FORM APPROVED
OMB NO. 1004-0135
Expires: July 31, 2010**SUNDRY NOTICES AND REPORTS ON WELLS**
*Do not use this form for proposals to drill or to re-enter an abandoned well. Use form 3160-3 (APD) for such proposals.*5. Lease Serial No.
NMLC029509A

3b. Phone No. (include area code)
Ph: 505-842-80008. Well Name and No.
MALJAMAR AGI 29. API Well No.
30-025-4262810. Field and Pool, or Exploratory
AGI

**Maljamar AGI #2
30-025-42628
Frontier Field Services
Conditions of Approval**

Running Horse AGI # 2 7" Cement Job

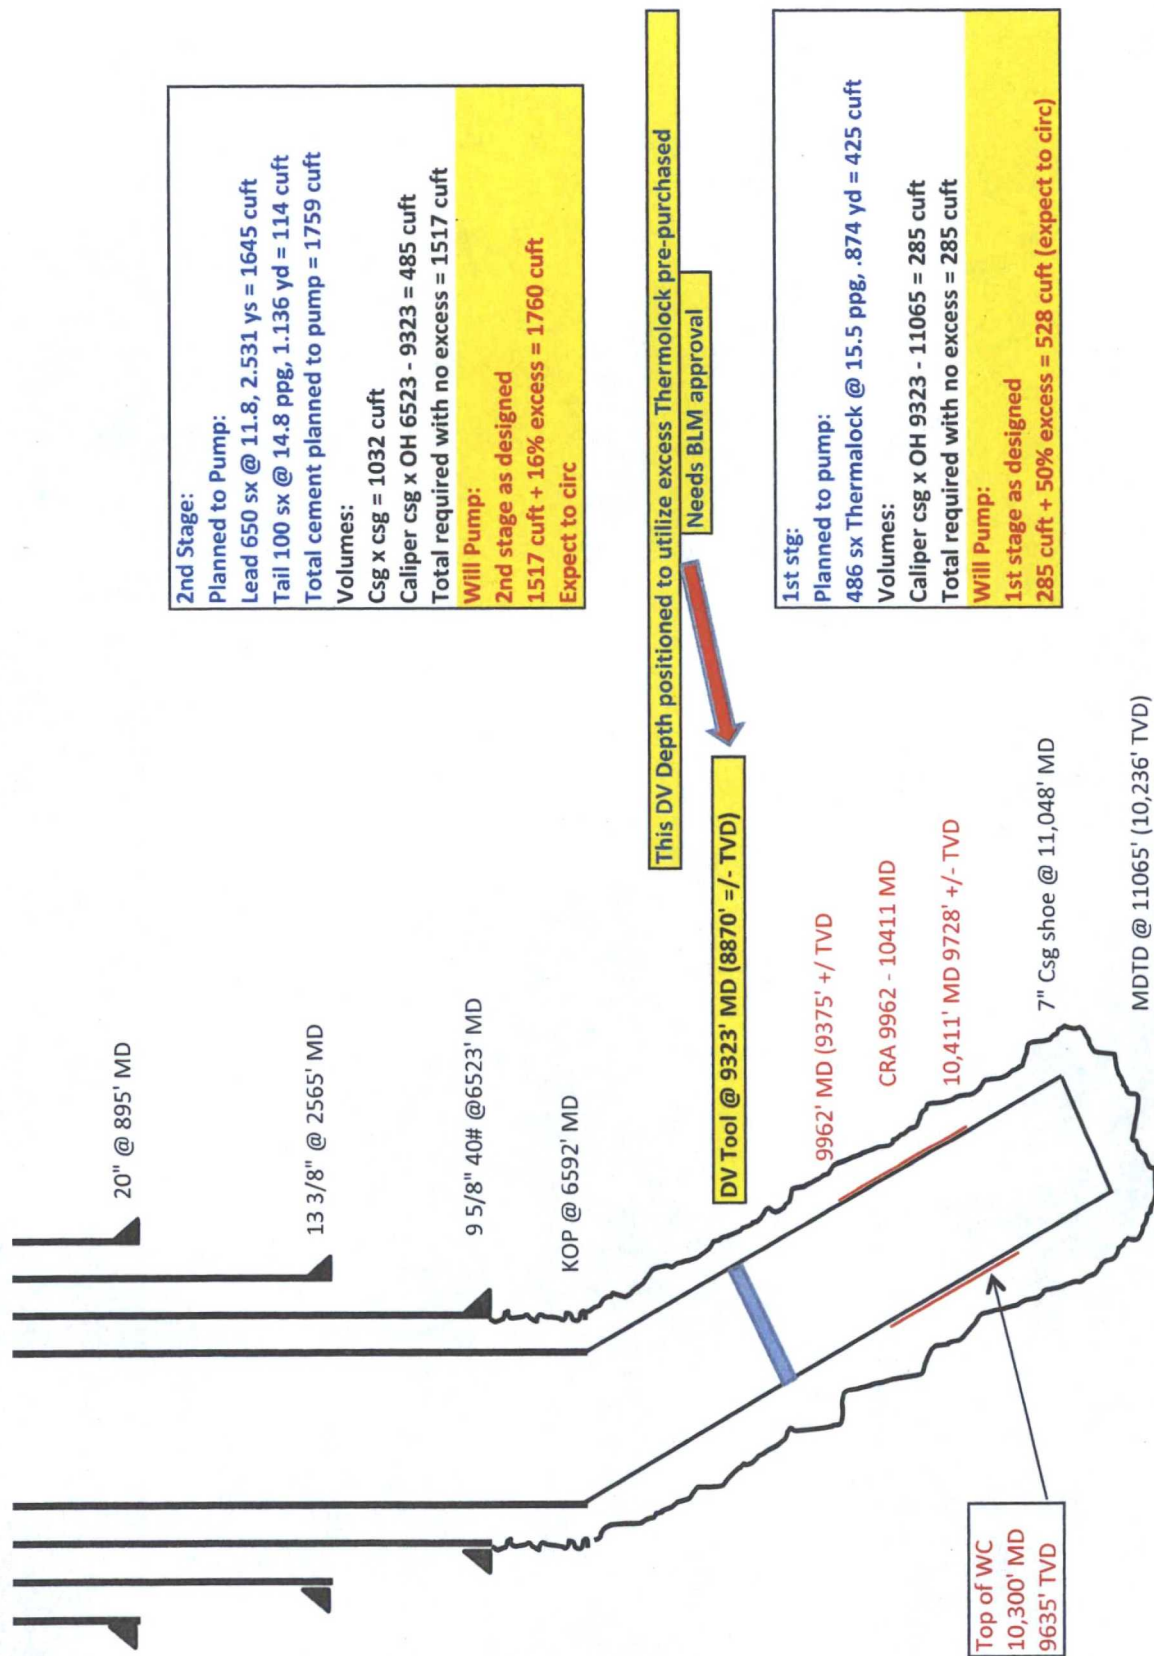
The most recently approved ADP indicated that the deviation (DV) tool for the 7-inch production casing would be set at 9,665 feet (9,137 feet TVD). The drilling consultant team requests that the measured depth of the DV tool be raised to 9,323 feet (8,870 feet TVD) to better utilize pre-purchased first stage (THERMALOCK) cement. The first stage cement volume will be 528 cubic feet (50 percent excess) and the second stage cement volume will be 1,760 cubic feet (16 percent excess). Both stages are planned to circulate to the surface. An updated well schematic indicating the proposed change has been attached.

Original COA still applies except for the changes for fill of cement requirement behind the Production casing.

1. The minimum required fill of cement behind the 7 inch Production casing is:

Operator has proposed DV tool at depth of 9323 feet. Operator is to submit sundry if DV tool depth varies by more than 100 feet from approved depth.

- a. **First stage using Class H lead to DV tool and acid resistant CORROSACEM cement Tail:**

☒ Cement to circulate. If cement does not circulate, contact the appropriate BLM office before proceeding with second stage cement job. Operator should have plans as to how they will achieve circulation on the next stage.

- b. Second stage above DV tool:

☒ Cement to surface. If cement does not circulate, contact the appropriate BLM office. **Wait on cement (WOC) time for a primary cement job is to include the lead cement slurry due to acid gas injection. Excess calculates to 21% - Additional cement may be required.**
